RONALD REAGAN SQUARE CONTRIBUTING ZONE PLAN MODIFICATION

Modification of a Previously Approved Contributing Zone Plan Checklist

4. Summary of Proposed Modifications (select plan type being modified). If the approved plan has been modified more than once, copy the appropriate table below, as necessary, and complete the information for each additional modification.

**Re: Ronald Reagan Square
Contributing Zone Plan Modification
Attachment B - Narrative of Proposed Modification**

WATER QUALITY POND PLAN

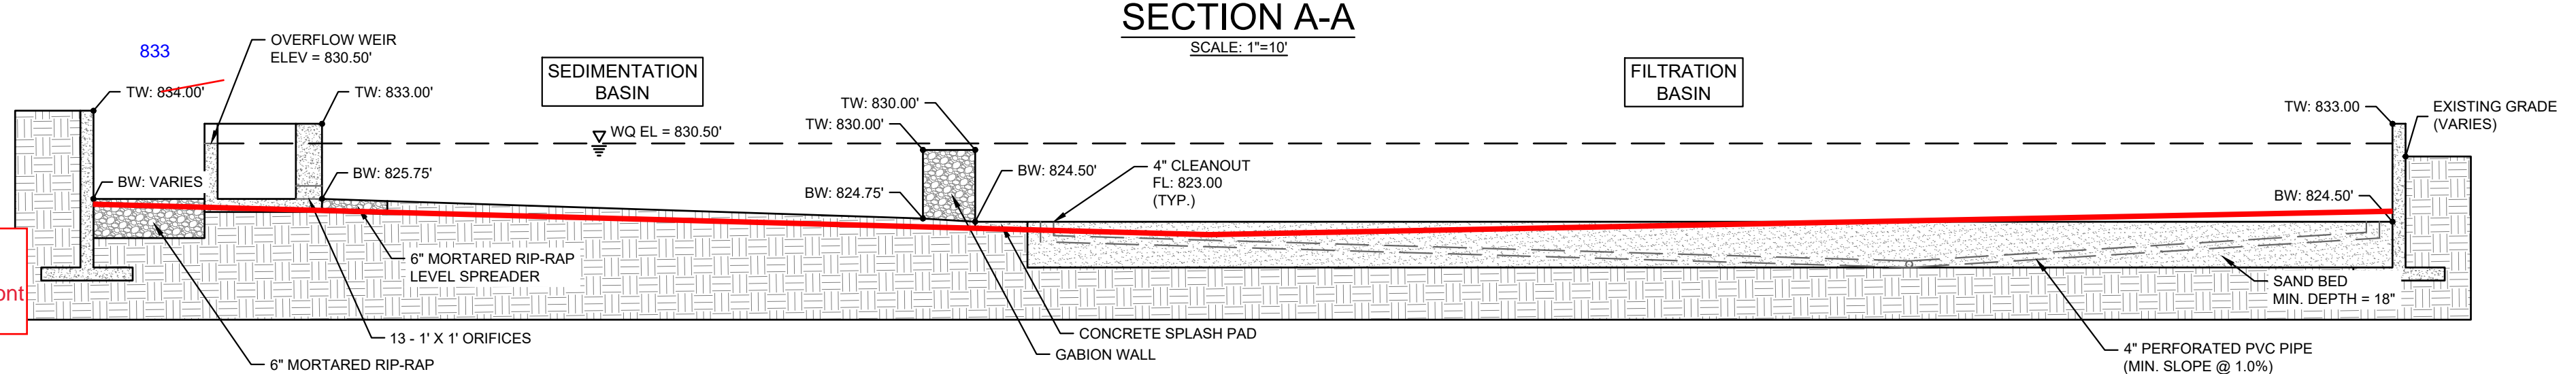
REPLACE WITH BATCH DETENTION DRAWDOWN TABLE
